August 31, 2001
DCS-TNW0108-05

Subject: Response to Request for Additional Information (RAI) No. 2 and Submittal of
Revision 5 of the Advanced NUHOMS® Storage System Application (TAC No.
L23203)

Docket 72-1029

RESPONSE TO REQUEST FOR ADDITIONAL INFORMATION TRANSNUCLEAR WEST INC., TAC NO. L23203

Figure 1 24PT1-DSC Temperature profile

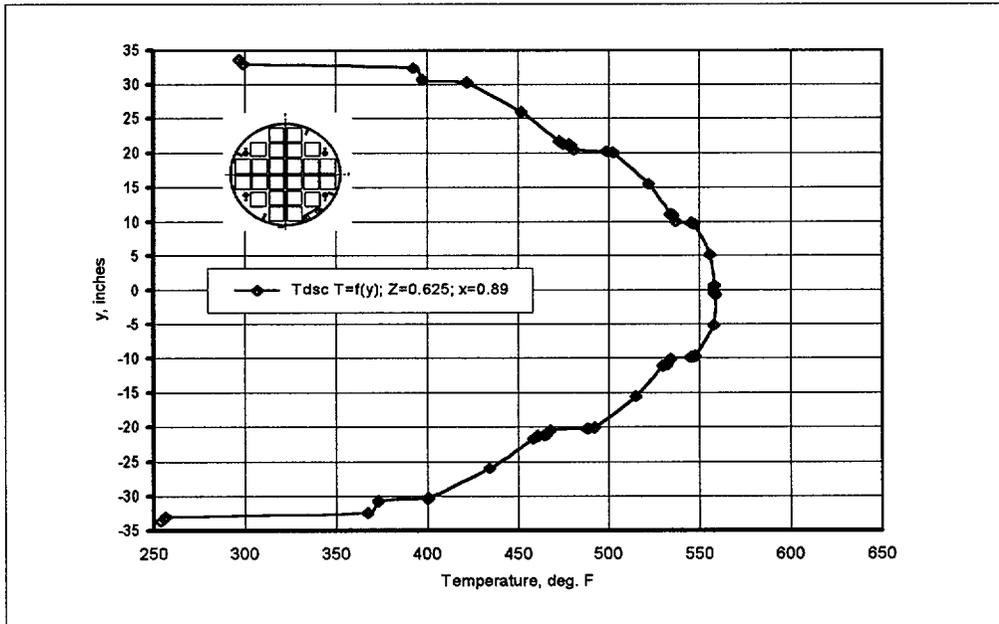
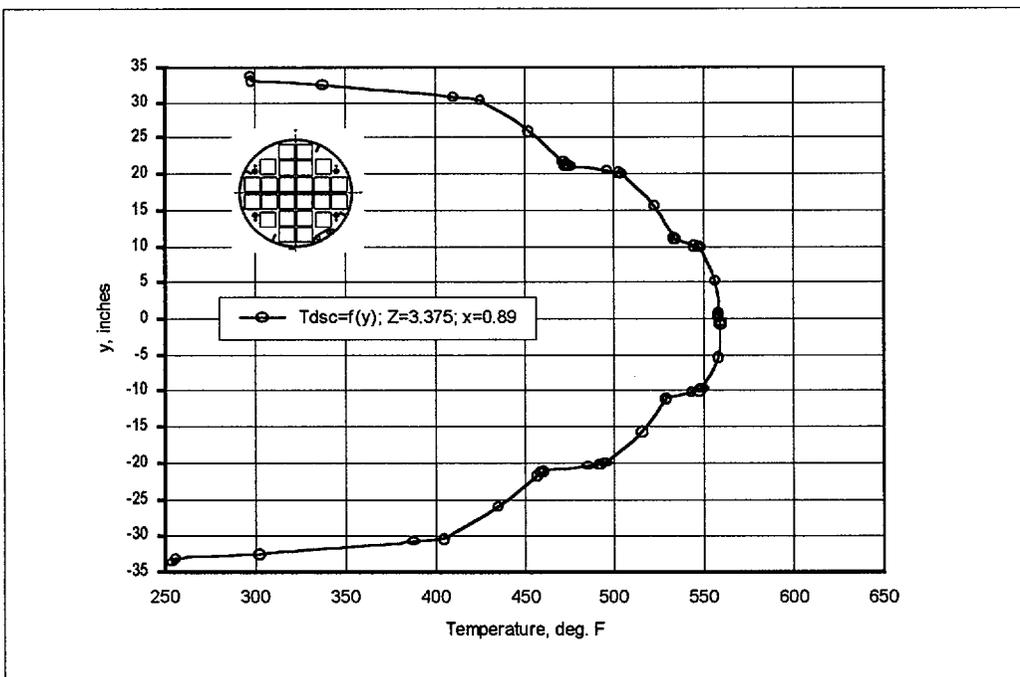
Question 4-1

Provide a radial temperature profile through the container for the normal storage condition case at 14 kW or a higher heat load that bounds 14 kW.

Include all temperatures of all components along the radial line, including inner and outer DSC shell, guidesleeve, boral plate, and oversleeve, as well as temperatures in the spacer disc and multiple fuel cladding temperatures across each fuel assembly traversed by the radial line. The fuel cladding temperatures in the plot should include the peak cladding temperature in each fuel assembly in the plot. The staff requires this information to assess compliance with 10 CFR 72.122(h)(1).

The MOX fuel configuration is addressed in this response due to the lower fuel clad temperature limit for the MOX fuel, 618°F versus 690°F for the SC fuel. Figure 1 of this RAI response provides a radial temperature profile through a 24PT1-DSC with a 13.706 kW heat load. This heat load represents the maximum heat load for a 24PT1-DSC containing one Mixed Oxide (MOX) fuel assembly and twenty three Stainless Steel Clad (SC) fuel assemblies. For a 14 kW DSC with all SC fuel assemblies, the maximum fuel clad temperature would be approximately 15°F higher than the results reported in Figure 1 for the MOX fuel configuration.

An additional HEATING run which is representative of the 24PT1-DSC Technical Specification heat load (13.706 kW representing the maximum heat load for a 24PT1-DSC with MOX fuel) has been performed using a 70°F ambient temperature. The Technical Specification heat load limit analysis results in a maximum MOX fuel cladding temperature of 558°F. A margin of 60°F is demonstrated when compared to the 618°F fuel clad temperature limit.

Figure 1 of this RAI response provides the temperature profile through the highest temperature locations in the 13.706 kW 24PT1-DSC analysis with the 70 °F ambient long term storage case. Two plots are provided to represent the fuel assembly temperature at the hottest cross section through a spacer disc and at the hottest location between spacer discs ($Z = 0.625''$ and $Z = 3.375''$ as shown in SAR Figure 4.4-8).
